**HORIZONTAL DIRECTIONAL DRILL ANALYSIS
HILDENBRAND ROAD CROSSING
PADEP SECTION 105 PERMIT NO.: E65-973
PA-WM1-0023.0000-RD
(SPLP HDD# S1B-0190)**

It is SPLP's intent to modify the original profile design and to pursue a deeper and longer HDD profile. Figure 1 in Attachment 2 presents the original HDD plan and profile. Figure 2 presents the revised HDD plan and profile.

HDD HYDROGEOLOGIC REEVALUATION REPORT

**Mariner East II
Spread 1
HDD S1B-0190
Hildenbrand Road
Sewickley Township, Westmoreland County, Pennsylvania**

ORIGINAL AND REVISED HORIZONTAL DIRECTIONAL DRILL PLAN AND PROFILES

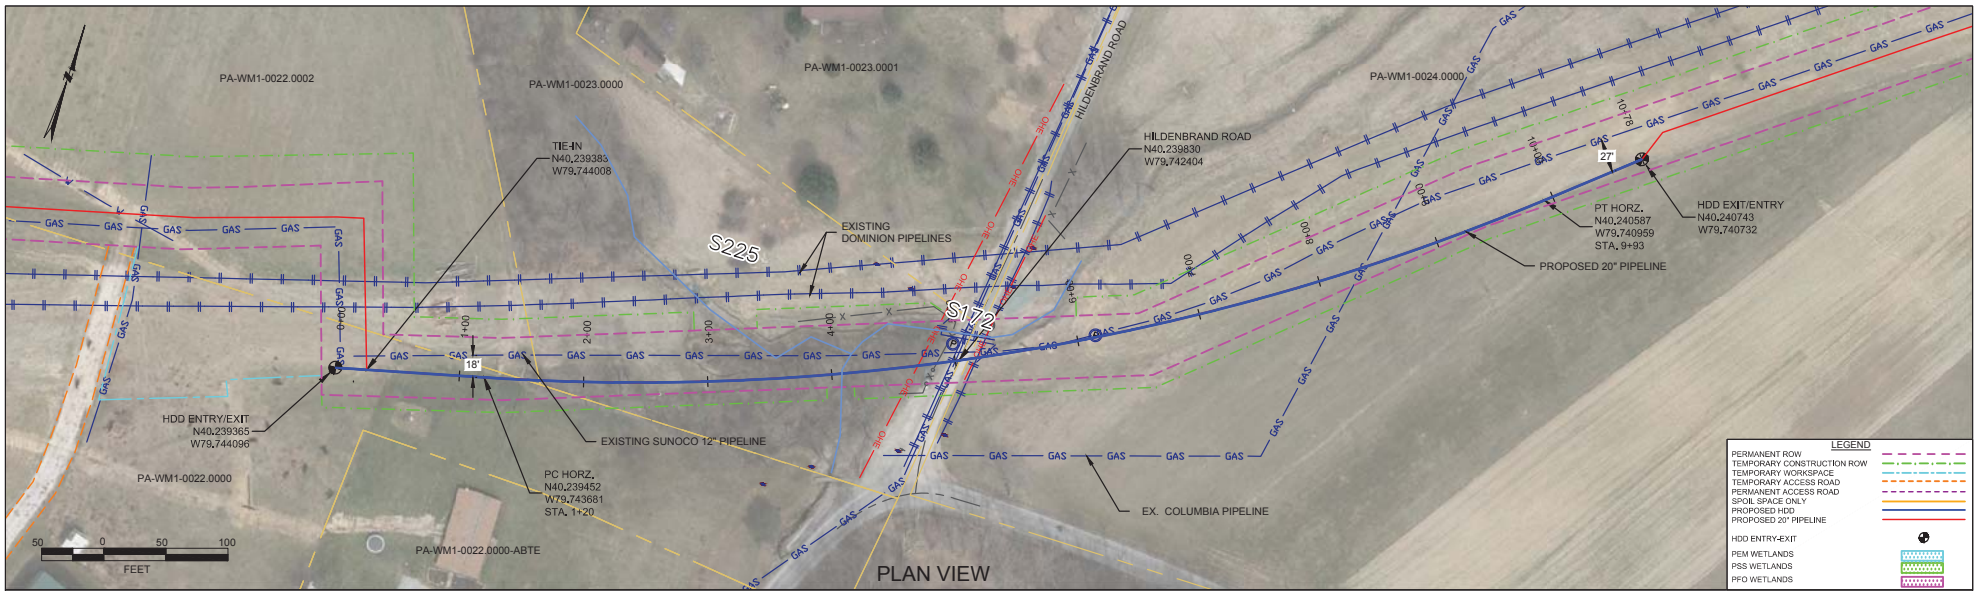
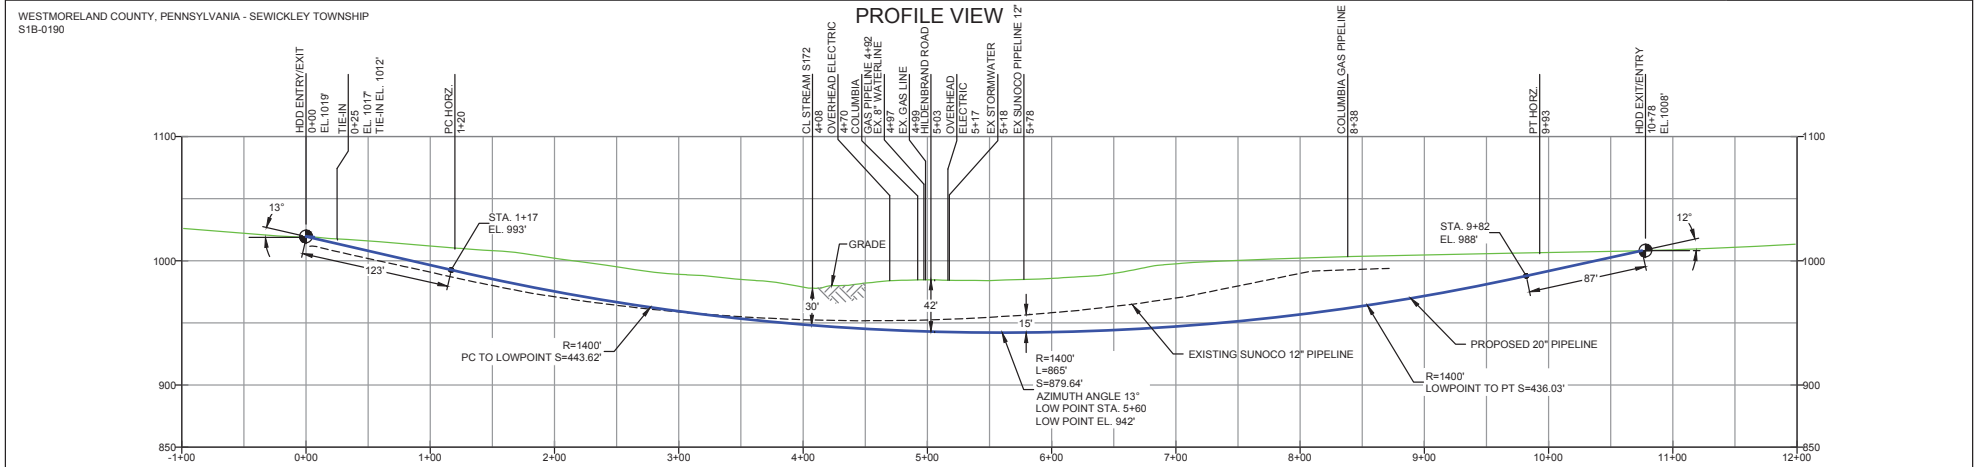
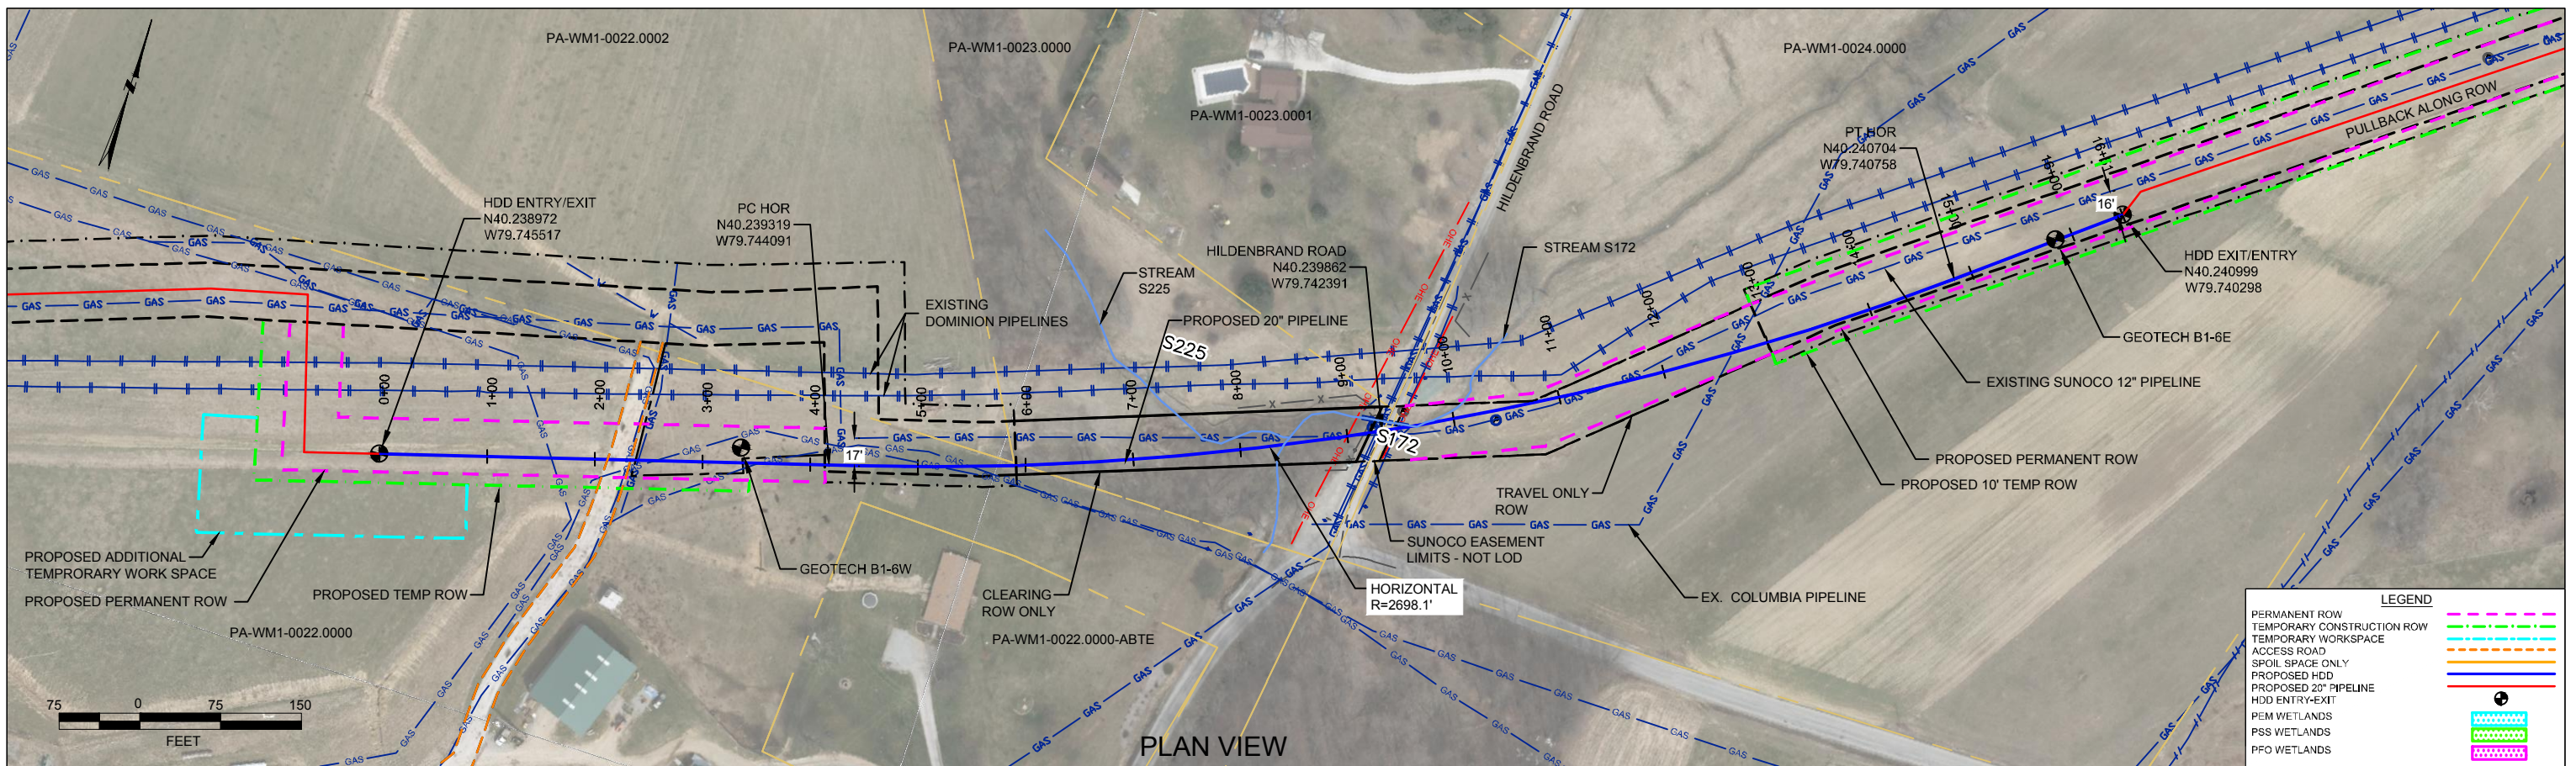
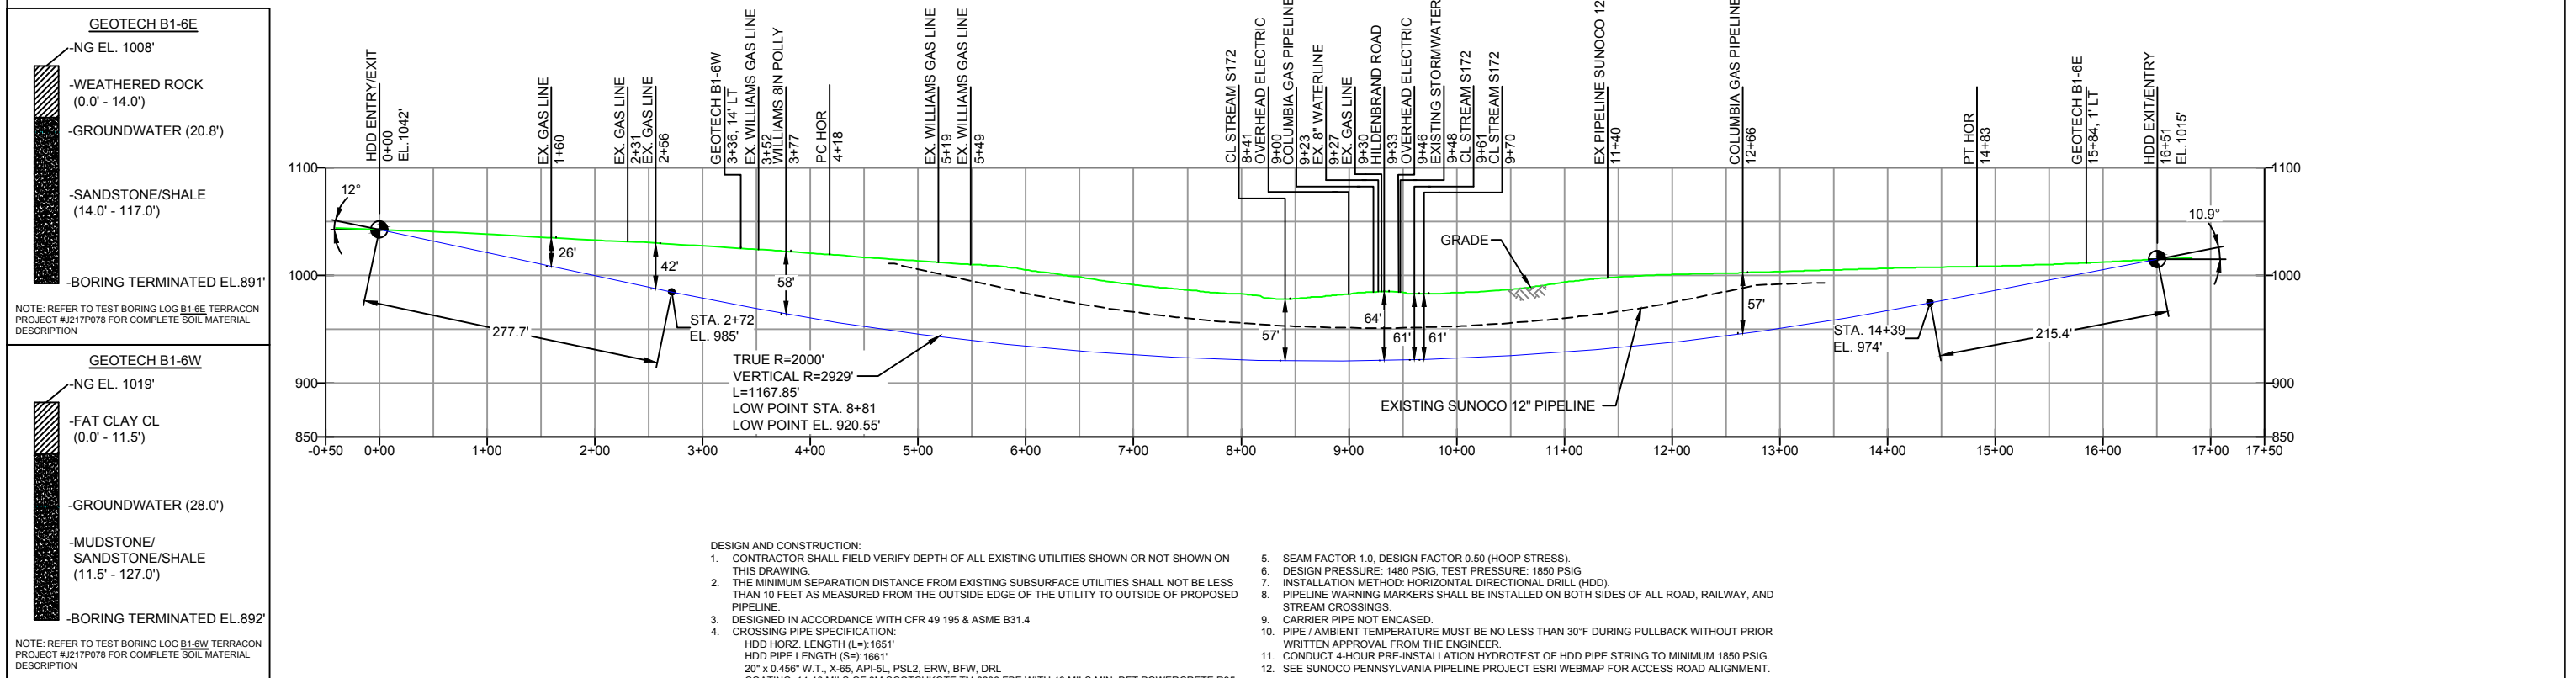
SPLP HDD consultants reviewed the HDD designs and geotechnical data for this area. Based upon this review, it was determined that the risk of IRs to waters overlying the HDD could be reduced by increasing the depth of the original permitted HDD profile. Additional geologic investigations have been completed and utilized in the redesign of the planned HDD. The redesign adjusts the HDD profile deeper to place the HDD pathway through bedrock having better structural integrity than a shallower profile and increase the overall length of the HDD due to pipe design requirements. A summary of the redesign factors is provided below.

- Horizontal length: 1,651 foot (ft)
- Entry/Exit angle: 11-12 degrees
- Maximum Depth of cover: 68 ft
- Depth of cover under streams: 57-61 ft
- Pipe design radius: 2,000 ft
